SITE DEVELOPMENT PLANS

LOT 3, APPALOOSA HIGHWAY 24 SUBDIVISION

Markup Summary

Subject: Callout
Page Label: [1] C-01
Author: Daniel Torres
Date: 9/4/2018 3:51:13 PM
Color: ■

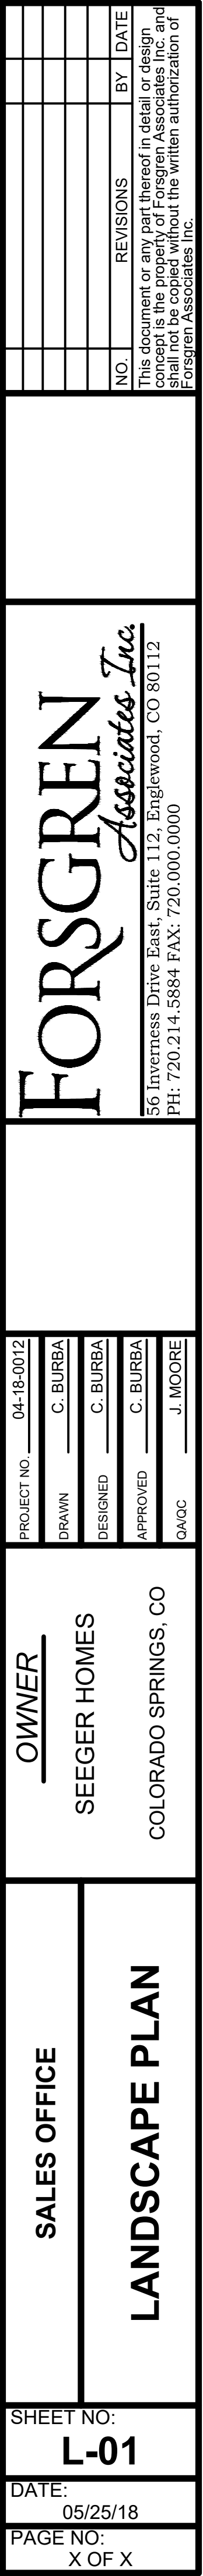
Trees cannot be installed directly over drainage facilities

Show the maintenance access to the outlet structure.

Roadway landscaping required. 25 foot buffer + 1 tree per 20 feet of roadway.

Internal landscaping required. 5% of total square footage. 75% of that must be live ground cover.

Roadway landscaping required - non arterial. 10 foot buffer plus 1 tree per 30 feet.

Parking lot needs to be screened - 3 ft tall berms or landscaping.
